Building Permit Application

RE: General Waiver Request
Russell McCampbell
18235 Penn Shop Rd.
Mount Airy, MD 21771

Re: Campbell Property
18235 Penn Shop Road
Sandmound Design

RE: Russell Campbell Property, 18235 Penn Shop Road, A530347

CONCEPT PLAN
18225 PINE SHOP ROAD
PARCEL BA MAP 8, ORD 4
LUBER BIRK FOLIO 339
MIDDLEBURY, MARYLAND

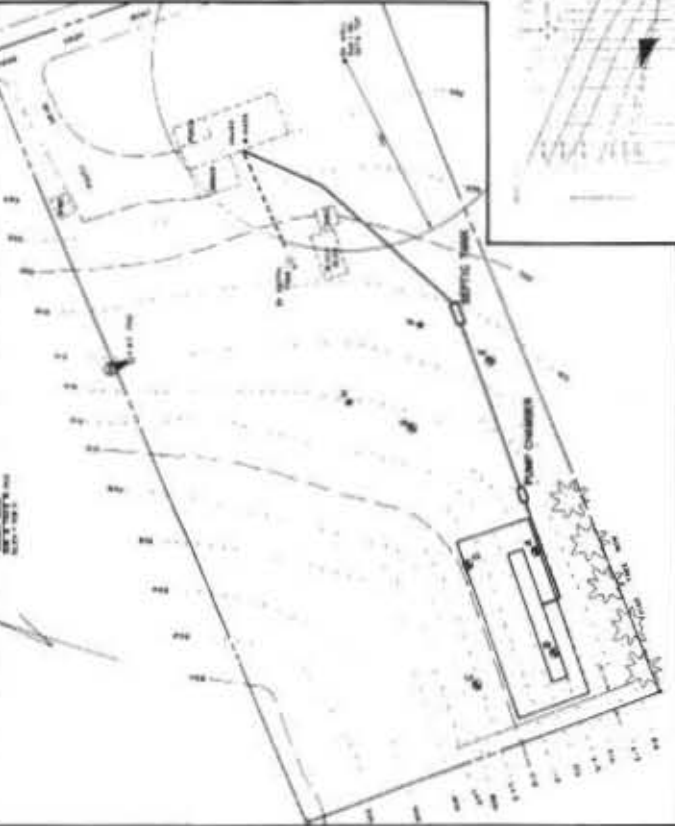
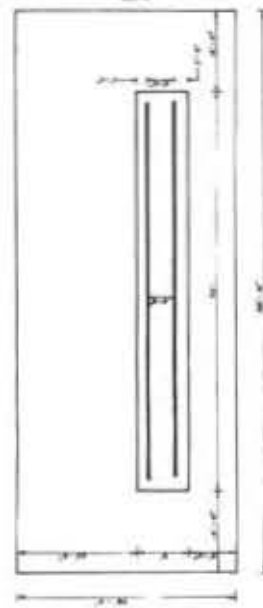
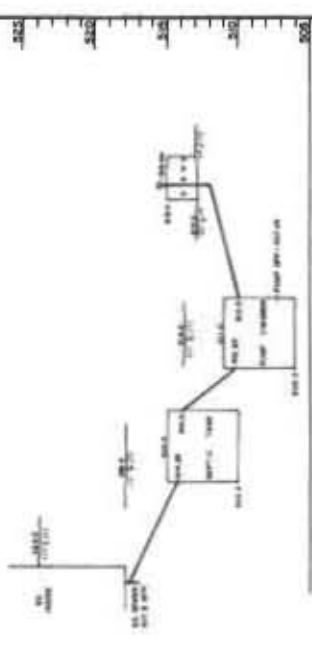
1. SOIL TEST. The correct times (min.) by respective test locations: A, 24; B, 32; C, 32; D, 12; E, 24; F, failed; G, 32; H, failed.
2. Lateral End Turn-Ups need to be on all 4 laterals.
3. The turn-ups need to be protected by sleeves as shown in Figure 4.5 of the Sand Mound Design Manual.
4. Observation pipes should be in the mound as indicated in Figure 3.1 of the Sand Mound Design Manual.
5. Concerning the site plan drawing:
 - a. Presentation of field-run elevation contours at 1-foot intervals is required.
 - b. The elevations of the 2 low corners of the sand mound should be presented (and be the same).
 - c. The elevations of the 2 low corners of the gravel bed should be shown.

The corners of the sand mound and the corners of the gravel bed need to be staked for inspection by an Environmental Sanitarian. The septic permit cannot be released until this inspection is conducted with a satisfactory result.

1. I totally misread a note on the field sheet concerning the test results. The correct test results are now shown on the revised drawings.
2. In the past Howard County has requested diagonal location of lateral end turn-ups as we showed on our plan. They are now shown on all 4 laterals.

3. Protective sleeves have been shown on the lateral turn-ups in place of the alternate choice of design shown in figure 4.3 of the design manual.
4. Observation pipes have been shown on the mound design and on the mound layout drawings. These were left off our drawing because several counties, including Howard County, have experienced problems from mowing due to above grade pipes. However, we have now shown them and will continue to do so on any Howard County plans we may prepare.

5. Field run 1-foot contours are shown and identified. Elevations requested on low corners of the mound and sandbed are shown.

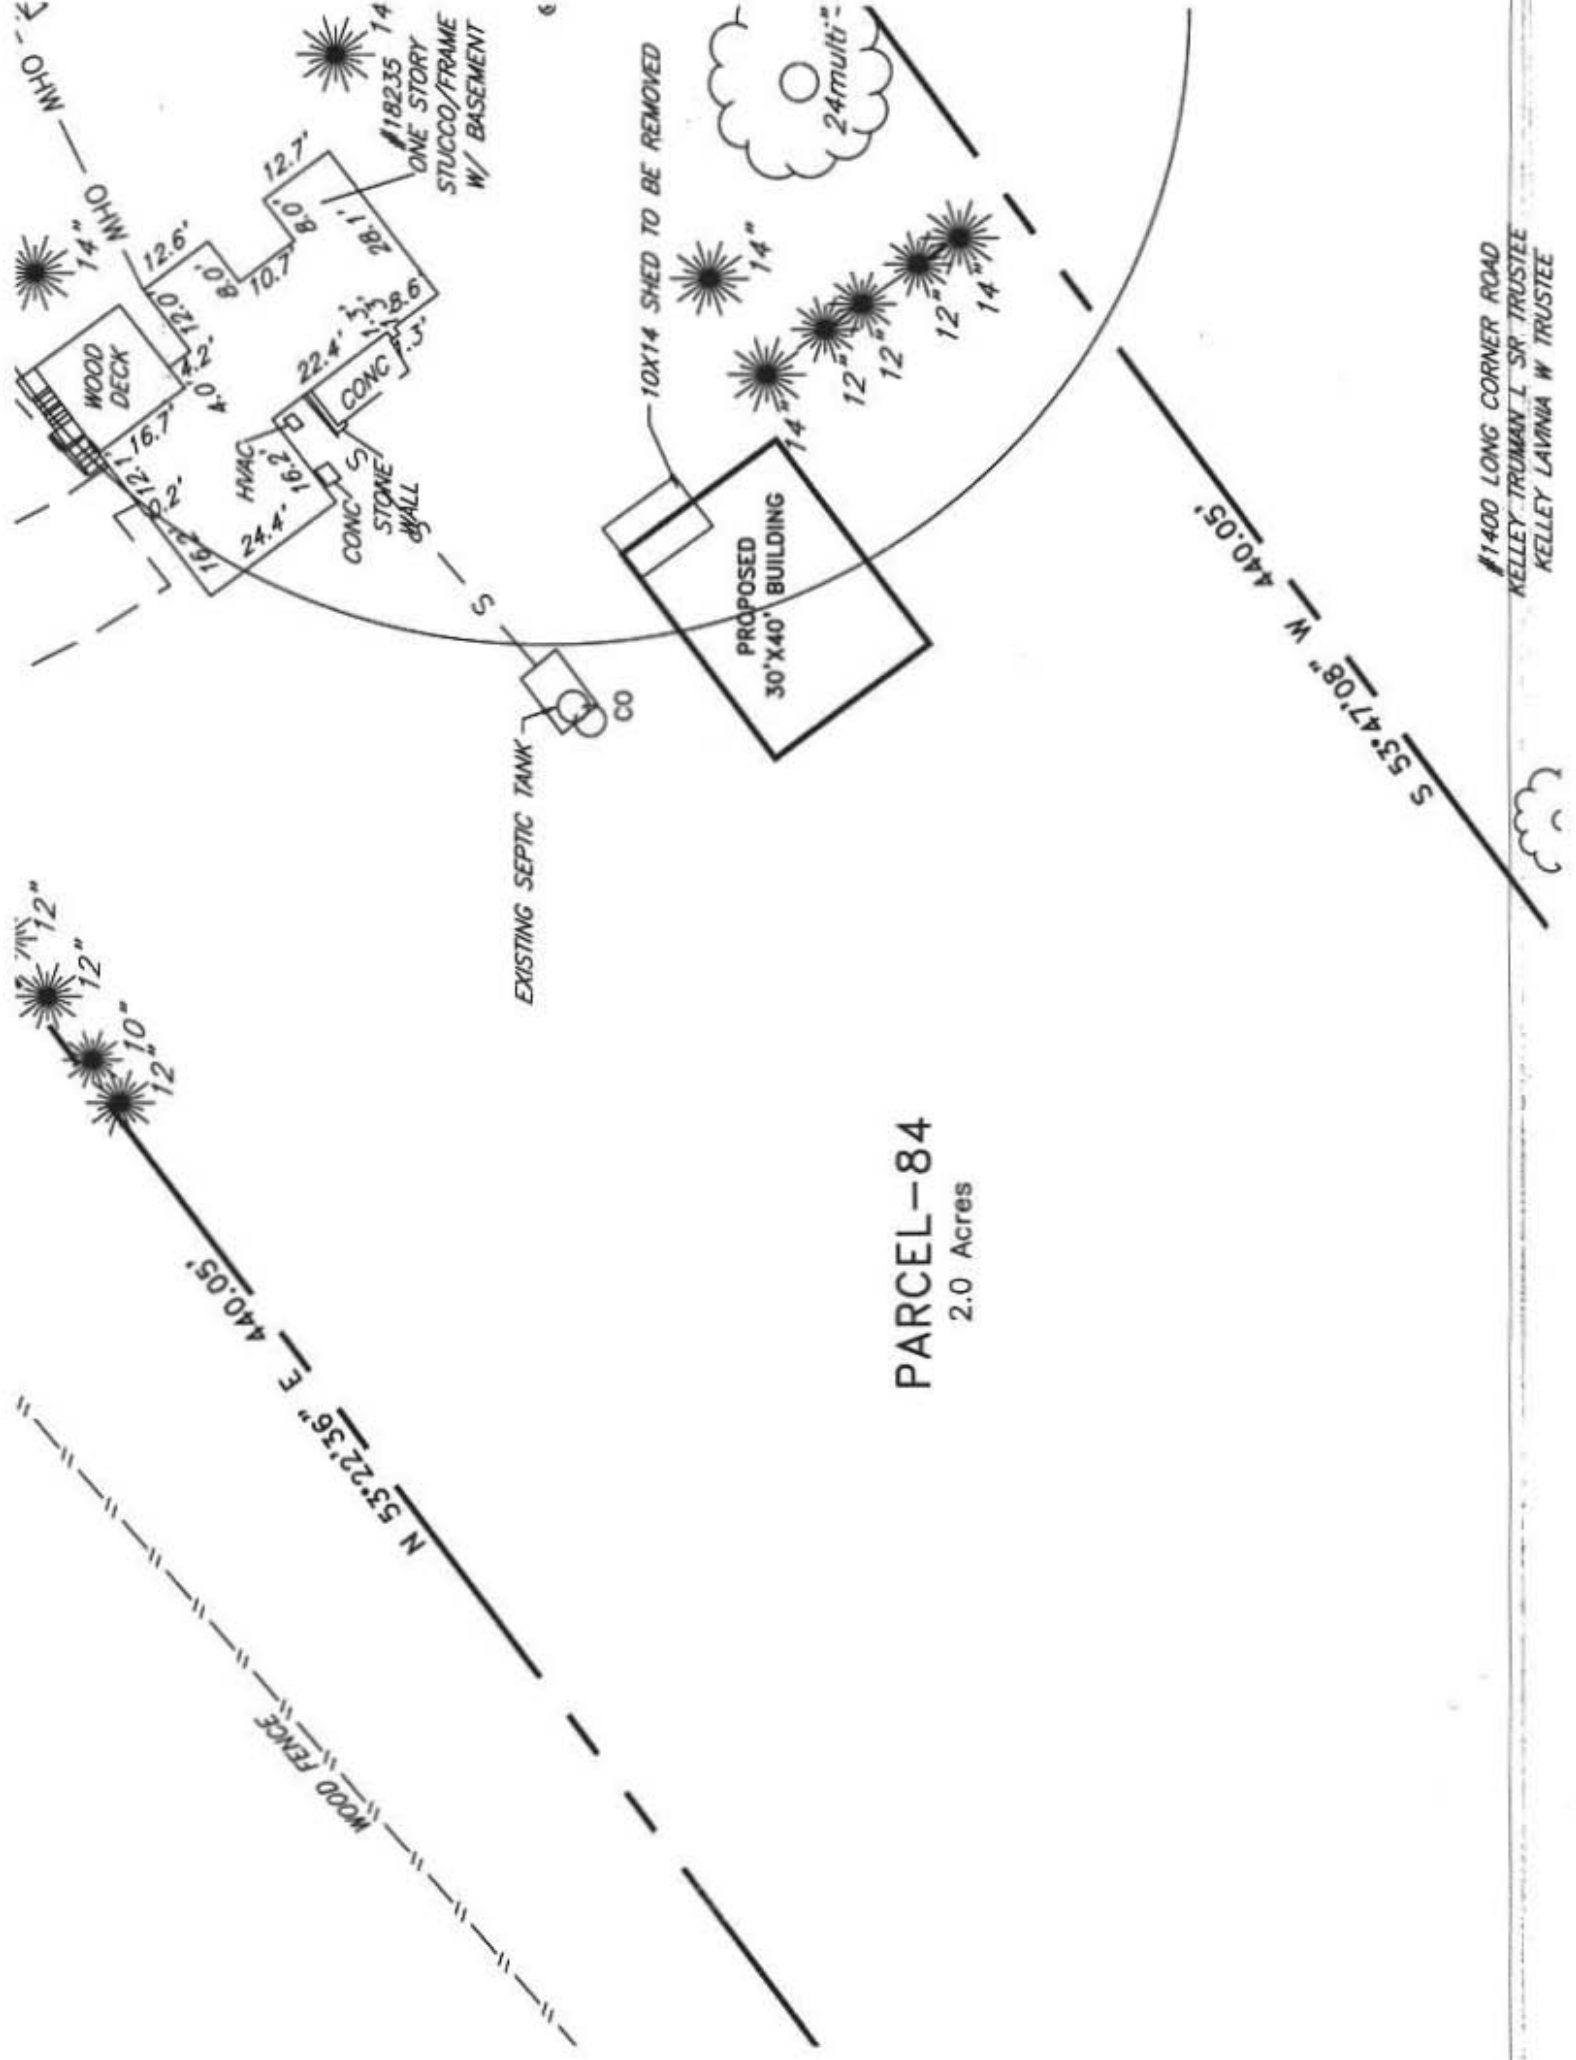
I have an update on your request. The reviewer of the application is requesting a plot plan. He needs to see the location of the proposed garage and the proposed area of the sandmound system if you were to install it in the future. Also, place the house , well, and the existing septic system on the plan. If you have any questions don't hesitate to send me an email. It sounds as if it is going to get approved. However, the plan will be required to make the final decision.
